Service Bulletin

AUTOMOBILE	
ISSUE NO. :	Q-SN-004
DATE	: Apr. 09, 2009
PAGE	: 1 OF 5

SUBJECT	: Steering vibration
APPLICABLE MODEL	: SN413(JS3JB43V834161319~. JSAFJB43V00170547~) SN415(SOP~)
EFFECTIVE ENGINE OR FRAME NO.	: 2009/3/2~ JSAFJB43V00422454~ (E02,E06,E11,E21,E22,E24,E37) JSAFJB53V00420452~ (E22) JS3JB43V3A4100053~ (E10) JS3JB43V694103542~ (E43) JS3JB43V294103554~ (E50) JS3JB43V694103556~ (E85)
REFERENCE	:

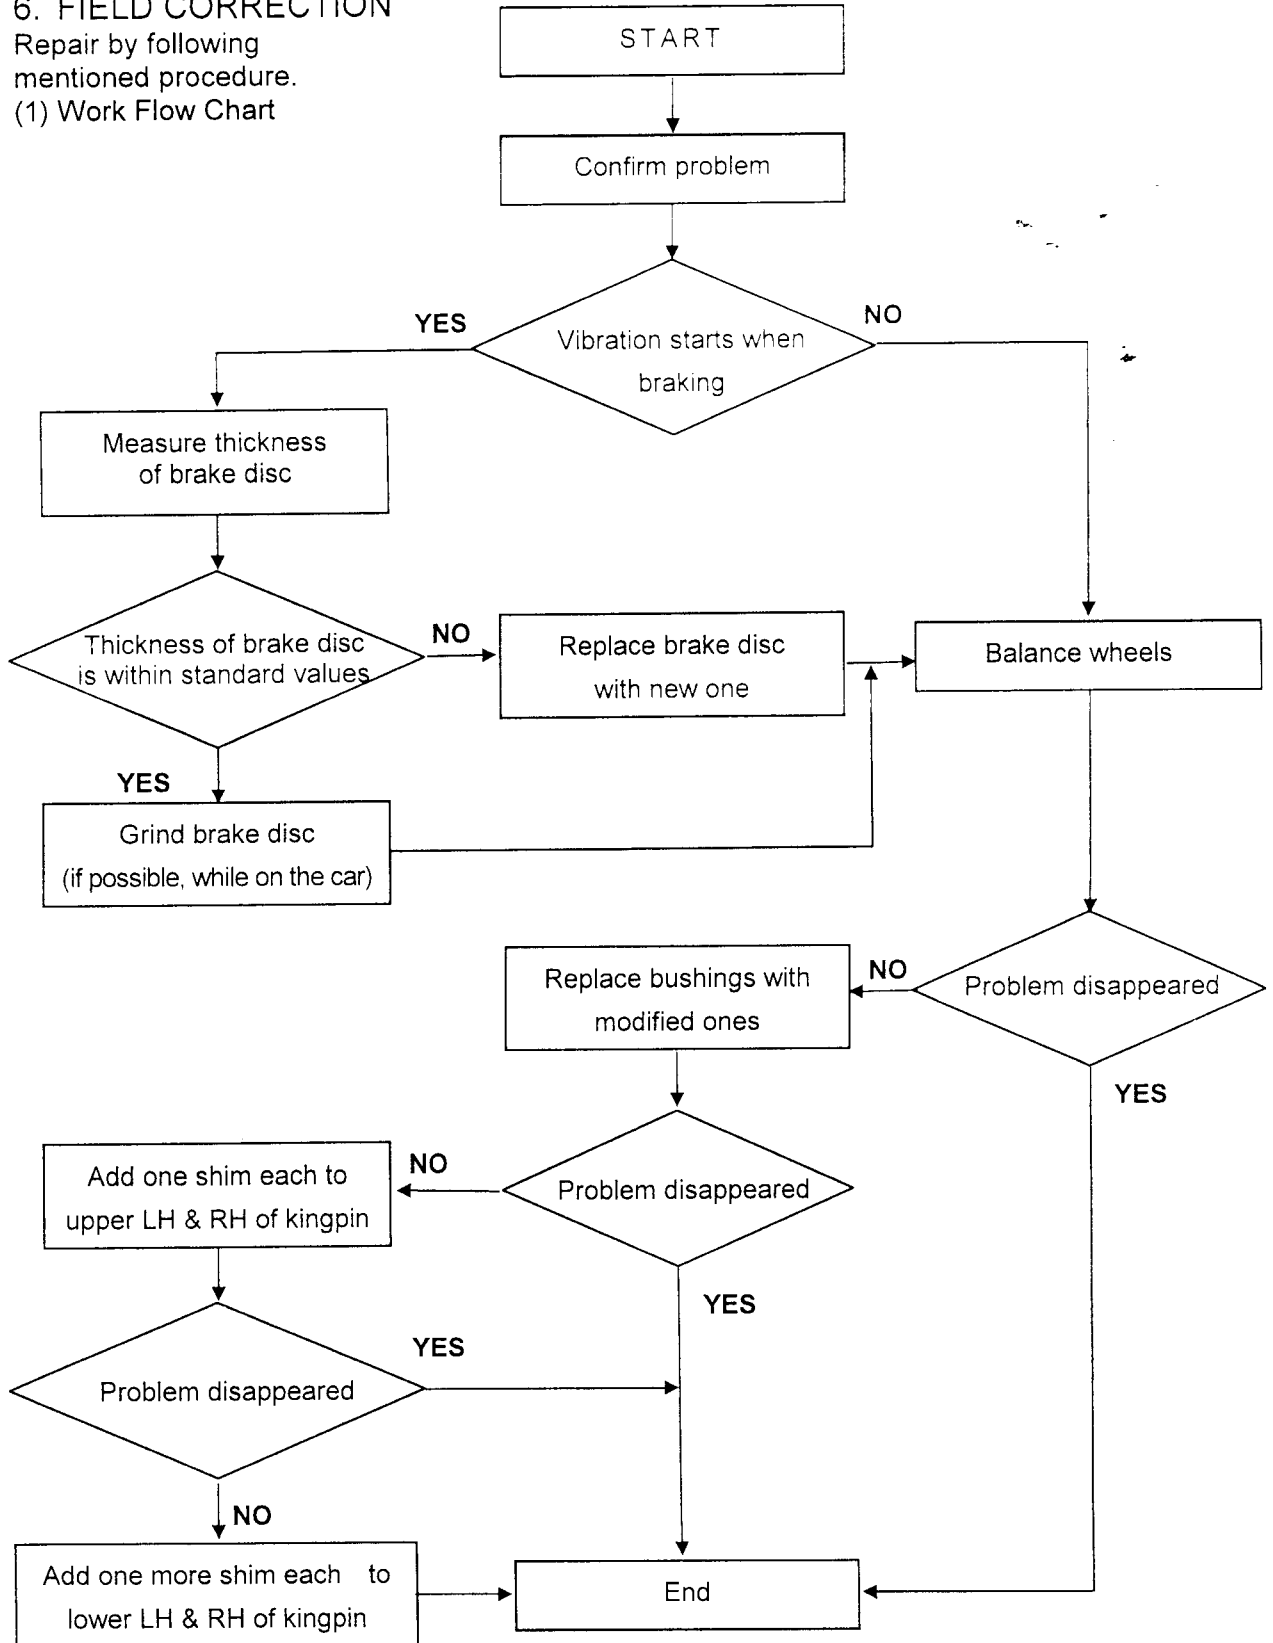
- By improving spring characteristic of front leading arm bushing, vibration transmission characteristic on front suspension has been changed.
- Shim has been set up as an optional part in order to adjust friction of steering system.

Repair by following mentioned procedure.
 (1) Work Flow Chart

FIG-1 : Location of additional shim

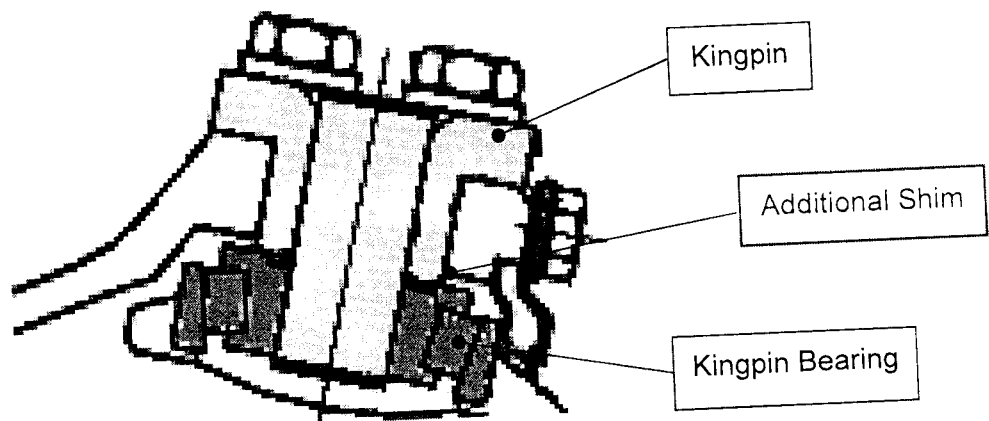
1. Remove kingpin, install the shim (FIG-1), and reinstall kingpin.
(Follow service manual for removal and assembly of the kingpin)

Put one shim in between kingpin and kingpin bearing.

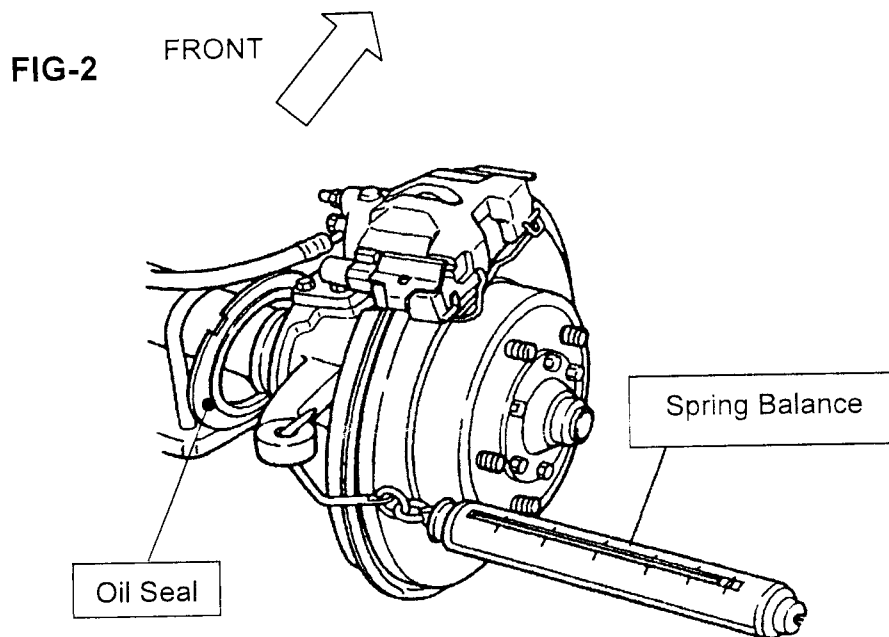
2. After adding shim, remove oil seal, tie-rod, and drag rod which are assembled on steering knuckle. And then, after shaking knuckle right and left around 20 to 30 times, measure start-up load by hooking a spring balance to tie-rod fixing hole of knuckle arm (which extends toward the rear of vehicle). Make sure start-up load is 4.6kg(45N) or less (Ref. : FIG-2).

CAUTION:
Please make sure start-up load should stay 4.6kg(45N) or less. If start-up load exceeds 4.6kg(45N), it might cause loss of steering returning performance or/and damage of kingpin bearing.
